NSW Independent
Planning Commission

Pitt Street South OSD

DESIGN OPTION
'CHAMFER'

IPC Request - 22 March 2021

The 'Telstra chamfer'

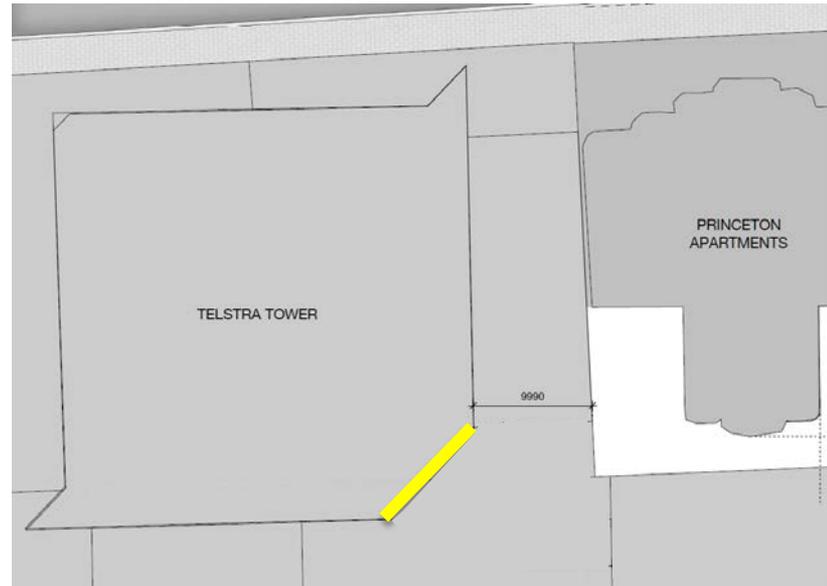
At the public meeting a number of residents of the Princeton Apartment building and a consultant planner made reference to a design option that had been explored by the Applicant, which included a chamfer to the south east corner of the proposed OSD tower. Could you please provide further details on this design and any potential benefits on solar access to the Princeton Apartment building and reasons why it was not progressed.

No written information has ever been provided by Princeton Apartments, its advisors or consultants to the applicant in relation to the 'Telstra chamfer'. The applicant is of the understanding that the 'Telstra chamfer' refers to the diagonal corner in plan of the building officially called '320 Pitt'.

This diagonal corner is shown at right in yellow.
